Subject: Duke Energy Carolinas, LLC
William States Lee III Nuclear Station - Docket Nos. 52-018 and 52-019
AP1000 Combined License Application for the
William States Lee III Nuclear Station Units 1 and 2
Response to Request for Additional Information
(RAI No. 3798 and 3799)
Ltr# WLG2010.04-02

Lee Nuclear Station Response to Request for Additional Information (RAI)

Reference NRC RAI Number(s): RAI 02.03.01-011

Reference NRC RAI Number(s): RAI 02.03.02-010

Figure 2DD-201
Stability Class Comparison
(Dec 2005 to Nov 2006)

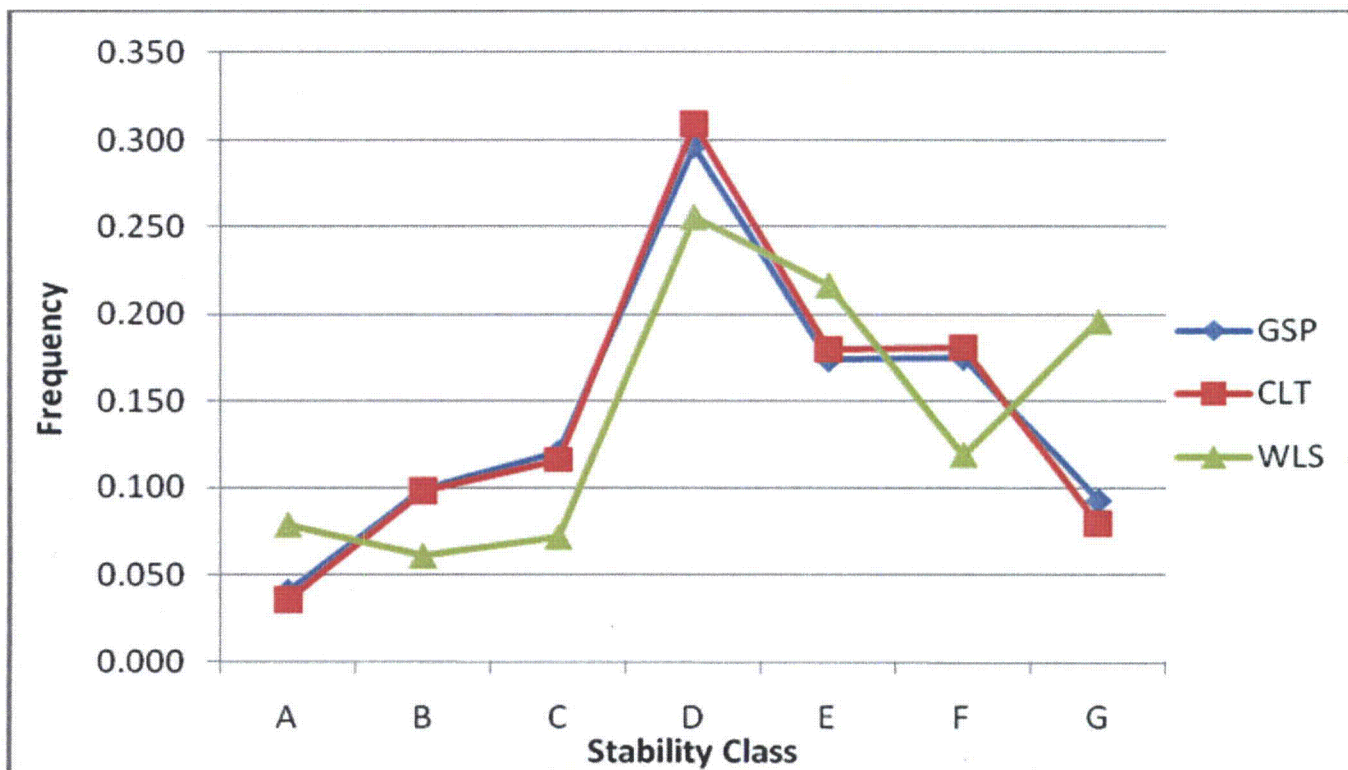
The stability class frequencies for the CLT weather station, the GSP weather station and Lee Nuclear Station site are compared in Table 2DD-201 and Figure 2DD-201. Stability class is determined at the NWS sites by the STAR method, which uses wind speed, cloud cover, and

ceiling height data in the calculation. The two NWS sites (i.e., Charlotte and Greer) have similar frequency distributions with fewer occurrences of the extreme unstable and stable classes (i.e., A and G stability class) for Greenville and more occurrences of neutral stability (i.e., D stability class). The Lee Nuclear Station stability classes, based on the vertical temperature difference (Delta-T) method, exhibit much more frequently occurring G stability class and stable classes (i.e., E, F, and G) in general with approximately 54 percent occurrence of the stable classes versus 44 percent for Charlotte and 44 percent for Greer. Therefore, the Lee Nuclear Station onsite stability class distribution would tend to produce lower plume rises. The differences between stability class frequencies between the NWS sites and the Lee Nuclear Station site is attributable to the location of the Lee Nuclear Station site in a shallow river valley, as well as the different methods used to determine the stability classes.

Figure 2DD-202
Relative Humidity Comparison
(Dec 2005 to Nov 2006)

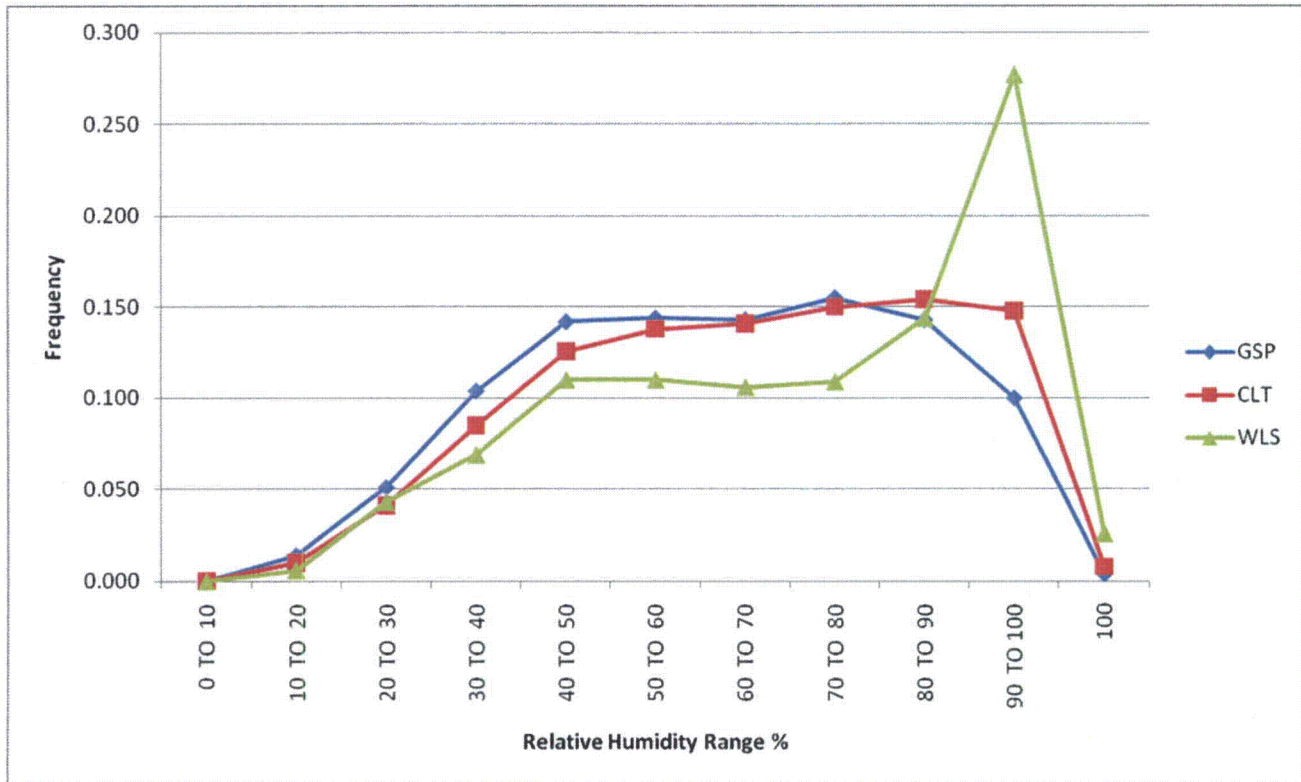
The annual average humidity data (i.e., relative humidity and dew point) compared in Table 2DD-201, as well as Figure 2DD-202 and Figure 2DD-203 indicates that the Lee Nuclear Station site has higher humidity than the other two locations and that Charlotte humidity is closer than Greer to Lee Nuclear Station humidity for the period. The dry bulb temperatures are compared between the CLT, Lee Nuclear Station and GSP in Table 2DD-201 and Figure 2DD-204. The annual average temperature values are very similar among all three sites, with Charlotte being almost equal to the Lee Nuclear Station annual average temperature.

Figure 2DD-205
(page 1 of 3)
Wind Direction Frequency
WLS Data (Dec 2005 to Nov 2007)

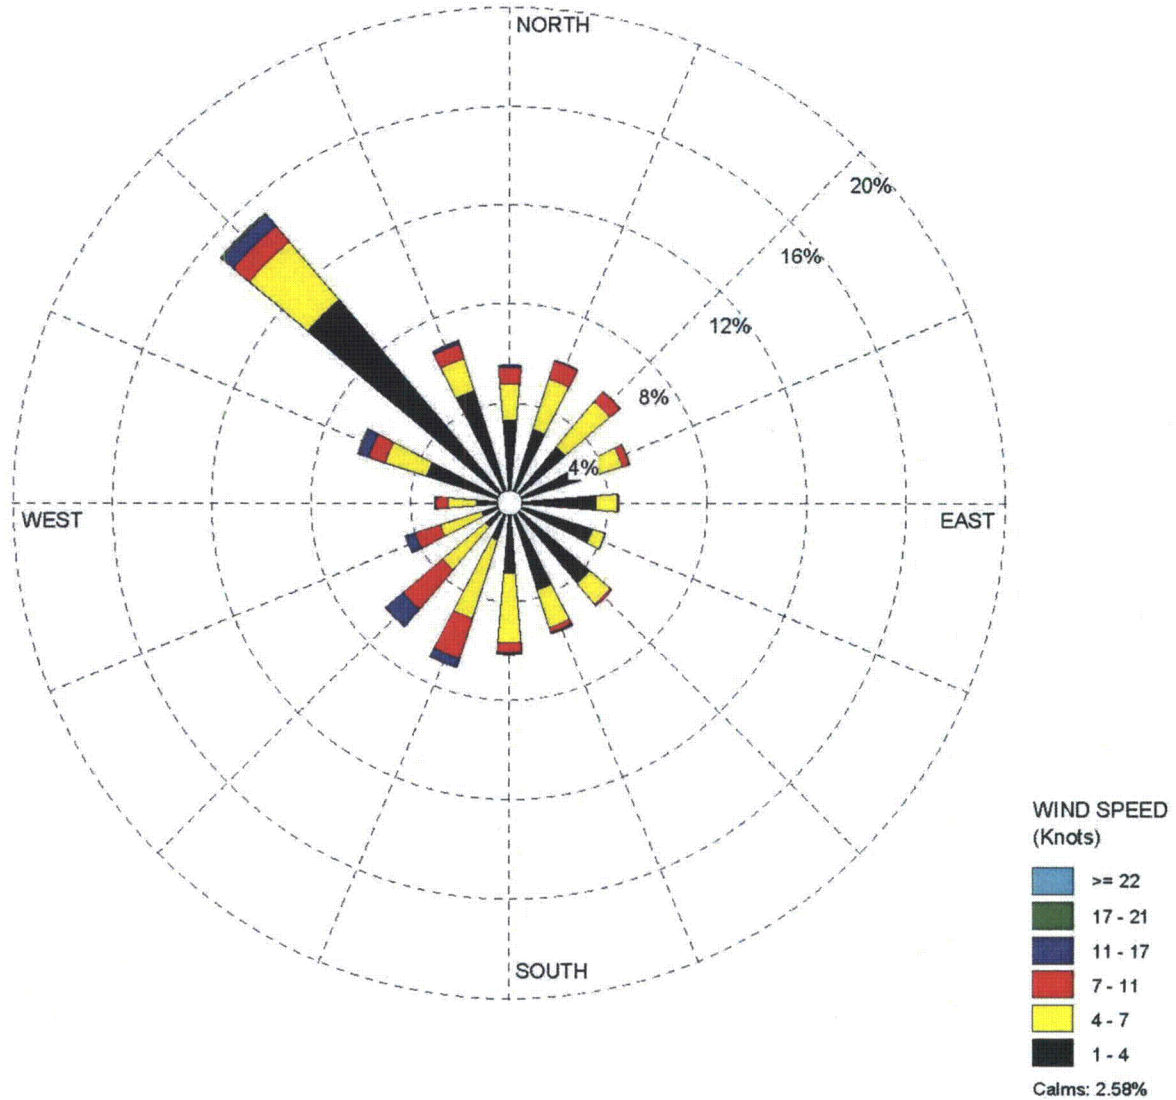
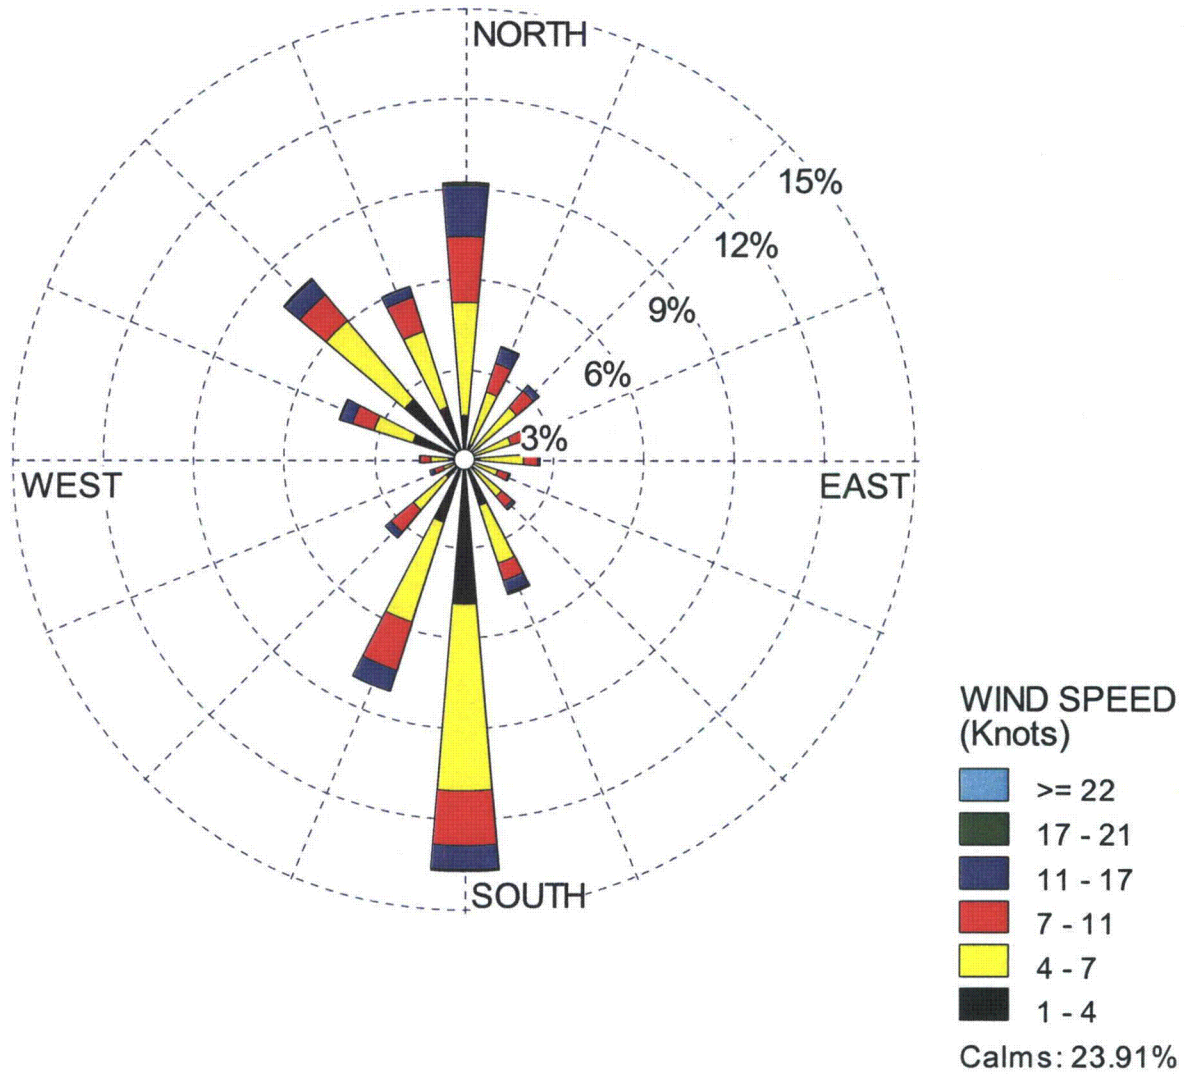
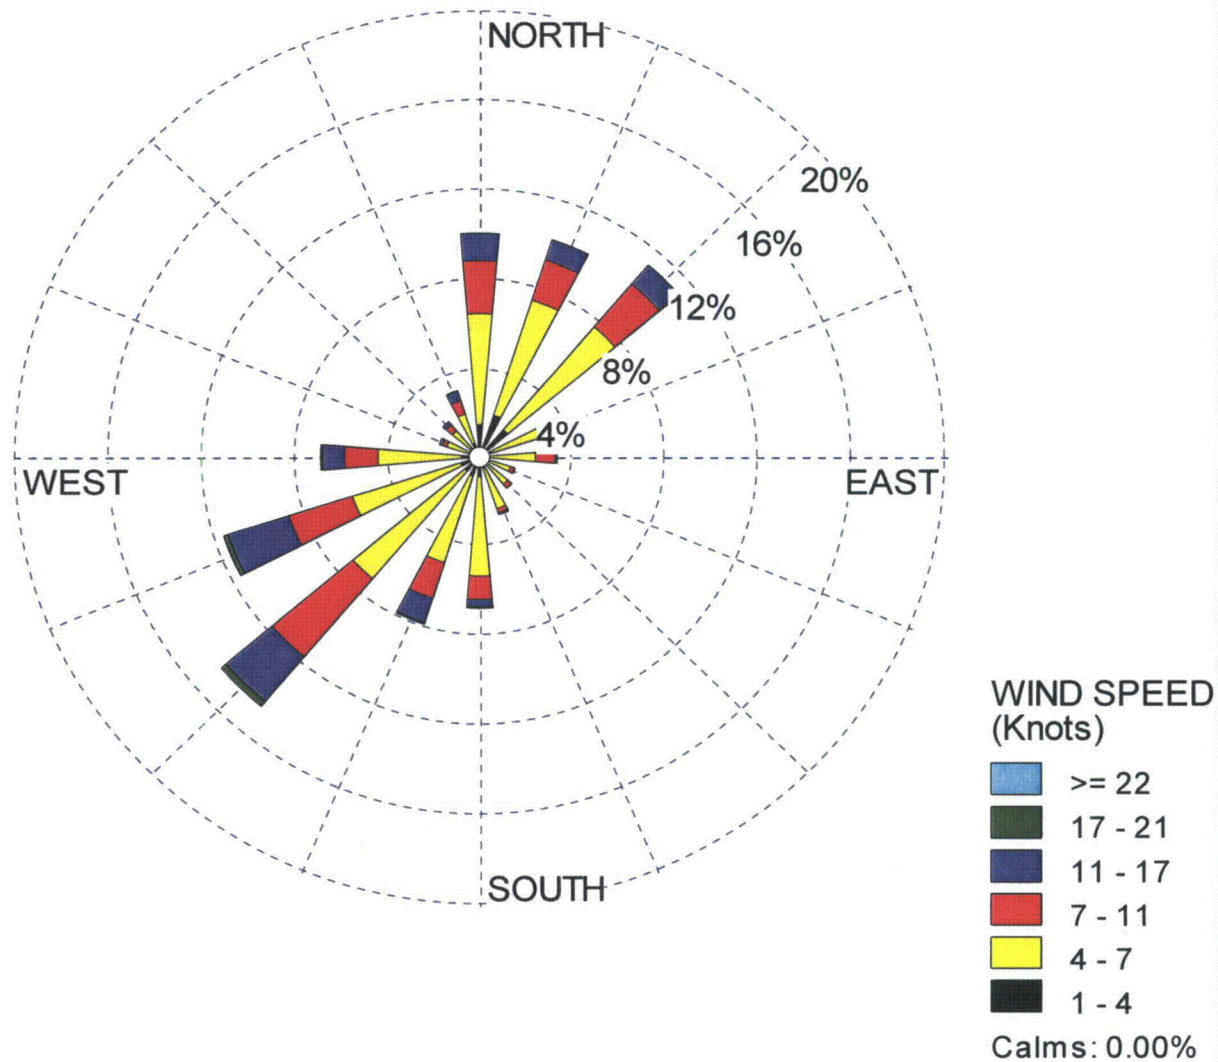
Figure 2DD-205, Sheets 1 through 3, shows the wind rose for each of the three sites, providing a comparison between the wind speed and wind direction frequencies. The wind roses indicate that the Lee Nuclear Station site has a much higher frequency of NW winds due to the local terrain than the other two locations, although there is a secondary maximum in the Charlotte data from the NW direction. Thus, in this respect, it is closer to the prevailing wind direction at Lee Nuclear Station. The Greer data show strong prevailing southwest and northeast winds. The Charlotte data is more from the S – SSW. Also note that at higher wind speeds, the similarity of the Lee Nuclear Station winds to the SW - S and NE - N regional wind pattern improves. This is demonstrated by a comparison of the Lee Nuclear Station wind rose with low wind speeds (< 5 mph) removed (Figure 2DD-206) with the CLT wind rose given in Figure 2DD-205, (page 2 of 3).
